TULSA METROPOLITAN AREA PLANNING COMMISSION

Meeting No. 2599

April 6, 2011, 1:30 PM

Alternative Compliance Landscape Plan – Southwest corner of East Apache Street and North Harvard Avenue; TRS 20-13-29; CZM 29; Atlas 285; CD 3; IM.

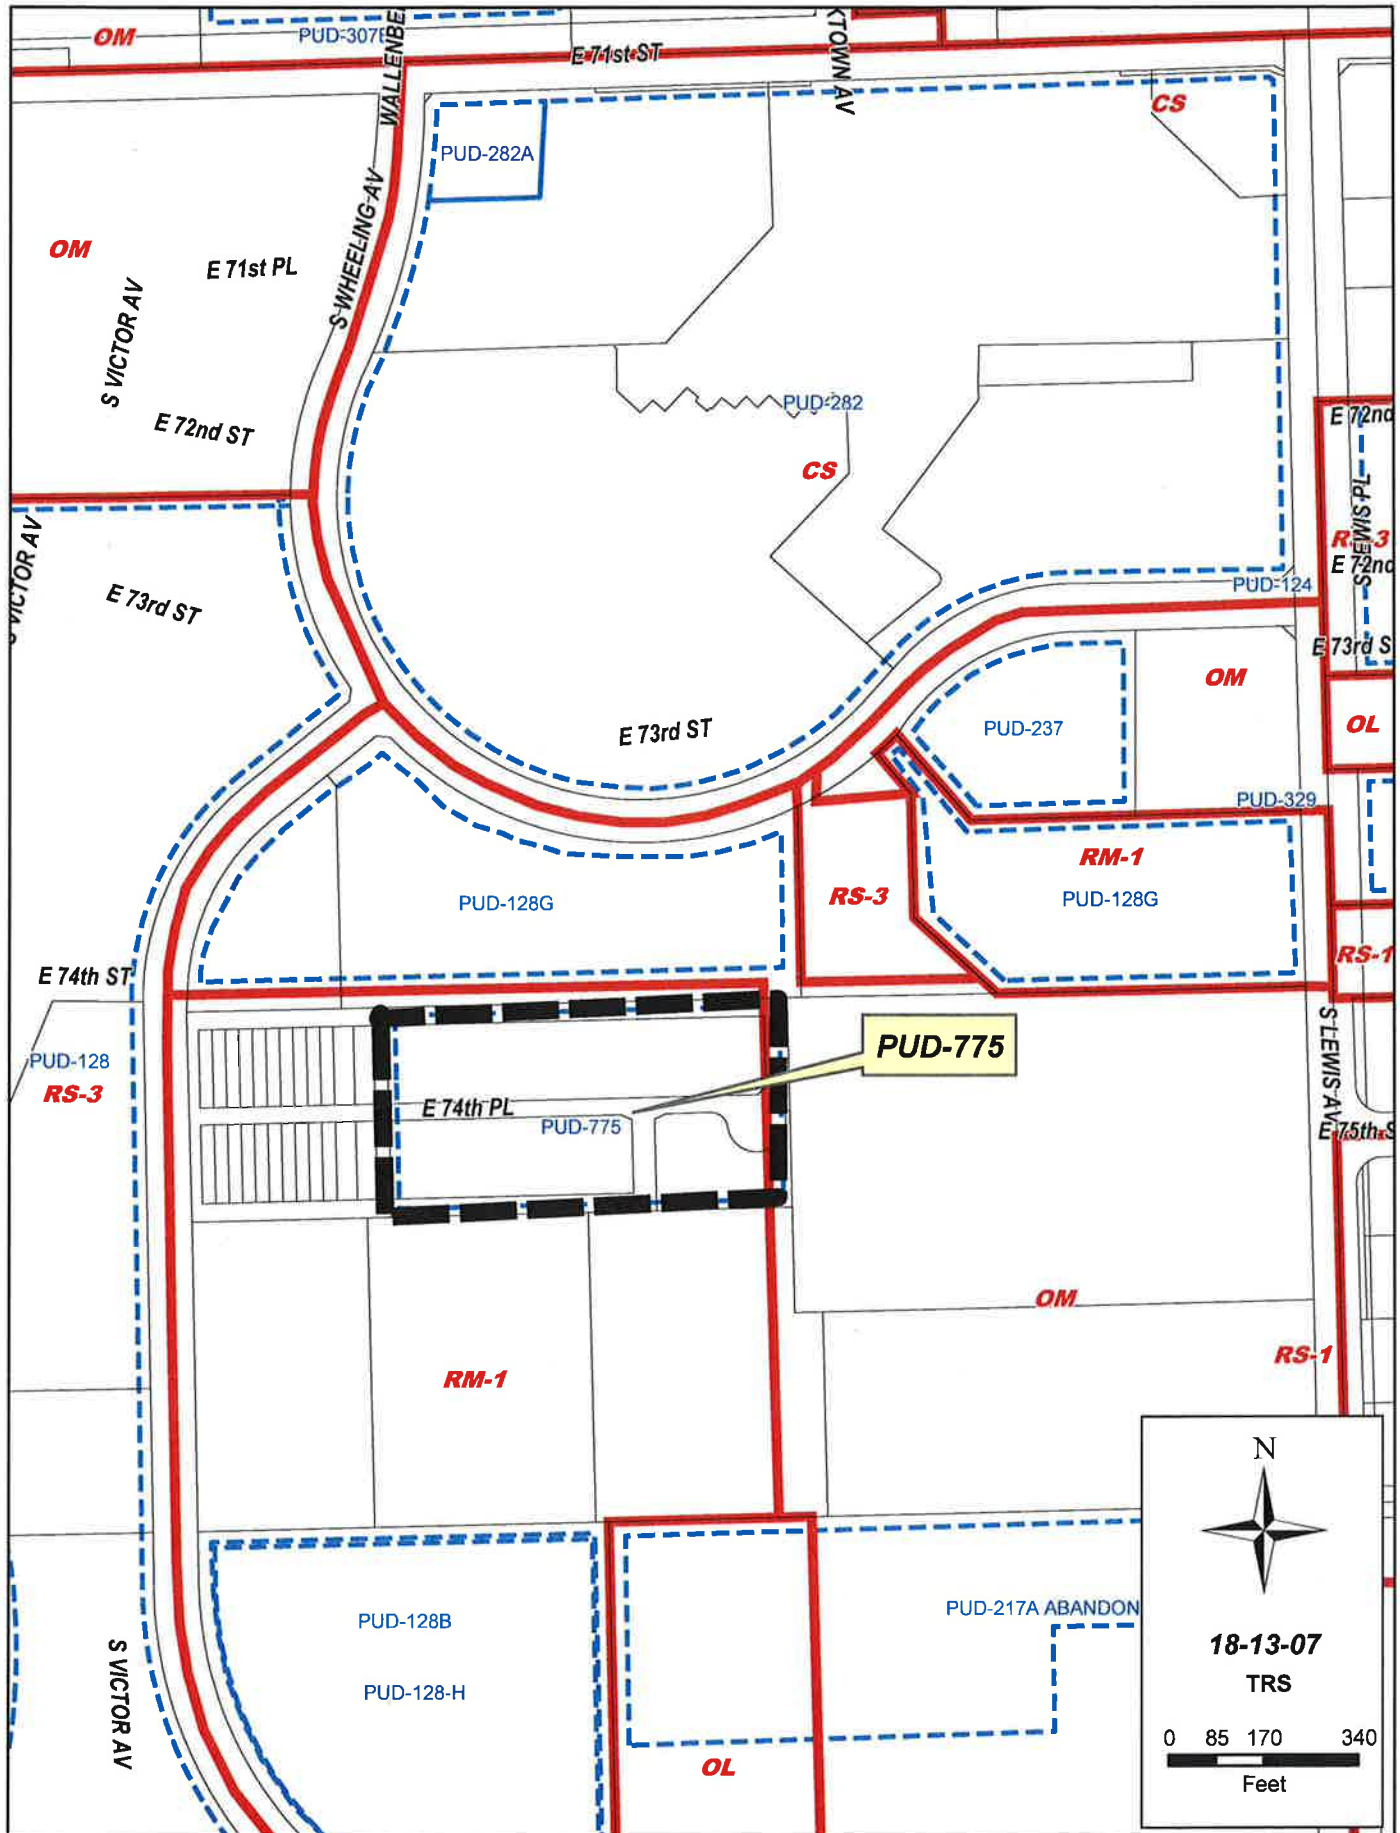
The landscape alternative compliance section of the code states that the Planning Commission may determine that, although not meeting the technical requirements of Chapter 10 the submitted plan is equivalent to or better than the requirements of Chapter 10 of the code.

§1002, A-5 of the code waives street yard landscaping on lots that have no street yard. The subject tract is zoned IM which has no building setback requirement from the property line along the arterial streets. By definition there is no street yard and therefore no trees required along the property lines in common with the streets.

In the alternative to having all parking spaces within 50-feet of a landscaped area, the applicant is proposing to landscape the entire street yard along North Harvard Avenue and Apache Street and plant more trees in these areas than are required by code. A total of 16 trees will be planted along the streets, when only one tree would be required in the parking area to meet the 1 tree for every 12 parking spaces requirement.

**ALL TRIBES
COMMUNITY
CHURCH**

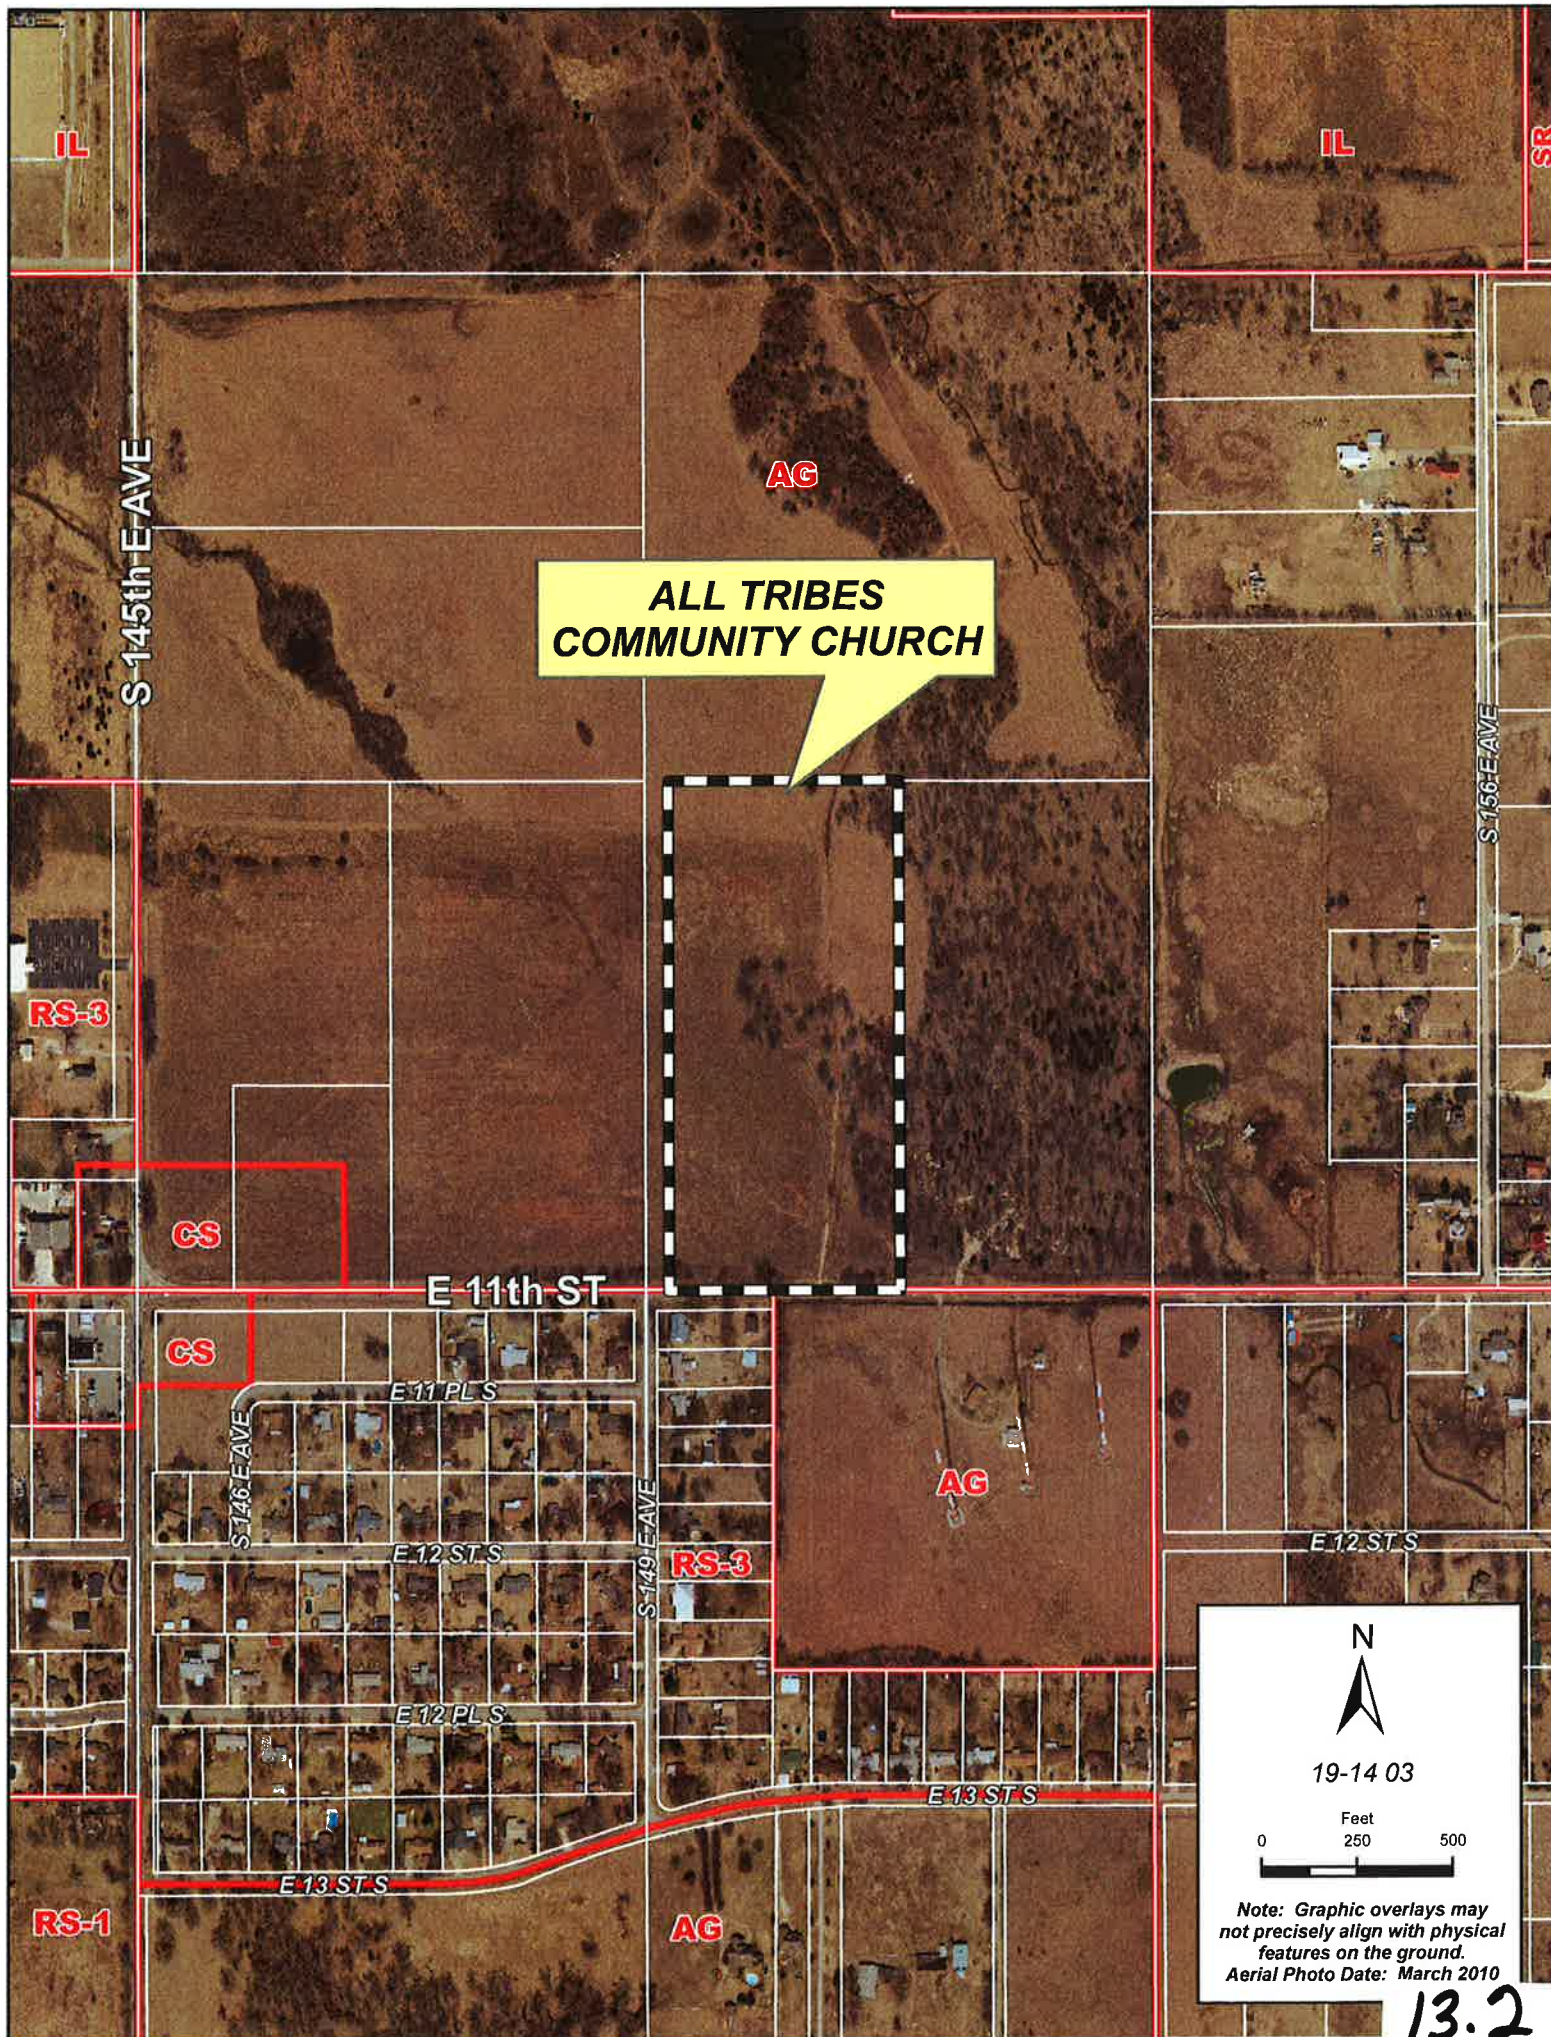
3. **Sewer:** No comment.
4. **Water:** Add City of Tulsa –Development Services; Address and Phone # 918-596-2569 for water on conceptual plans. Call out to stabilize the entrance drive from 11th Street over the existing 8 inch waterline. Show the existing 8 inch waterline inside the right of way of 11th Street. All water service meters are installed inside the street right of way or a dedicated easement.

5. **Storm Drainage:** No overland drainage easements (ODE's) are identified on the face of plat. Either show them or delete the paragraphs discussing them. All offsite runoff should be collected at the property line and conveyed across the site in either a drainage easement (if piped) or an ODE.

leading zero in bearing degree descriptions on the west and east side of the plat for consistency. Submit control data sheet. Provide a metes and bounds legal description of the subdivision with bearings and distances to match what is shown on the face of plat.

1. The concerns of the public works department and development services staff must be taken care of to their satisfaction.
